## **REMARKS**

In the Office Action dated December 29, 2005, the Examiner objected to the drawings as allegedly not showing every feature of the invention specified in the claims, namely the features of (1) the “transponder cannot be removed from the light guide without damaging the transponder”; (2) the “alert device”; and (3) the “display device”.

Fig. 1

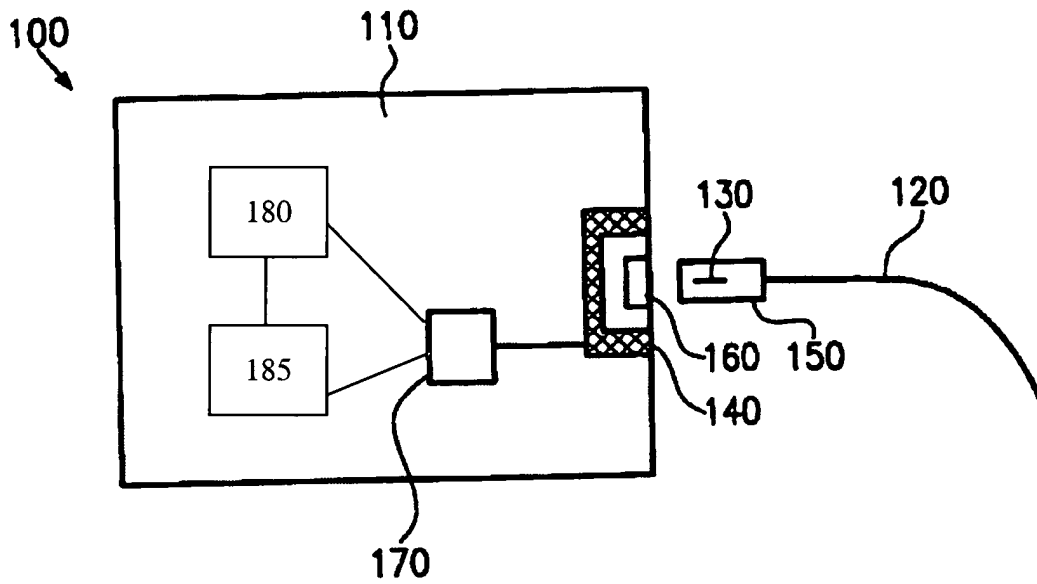
Regarding the alert device and the display device, Applicants have submitted concurrently herewith a request to enter amended Figure 1 to show each item in the laser device of Figure 1. In the amended Figure 1, reference numeral 180 refers to the display device and

reference numeral 185 refers to a system controller. The alert device is a component of the system controller. Applicants have amended the specification to insert the reference numerals where appropriate.
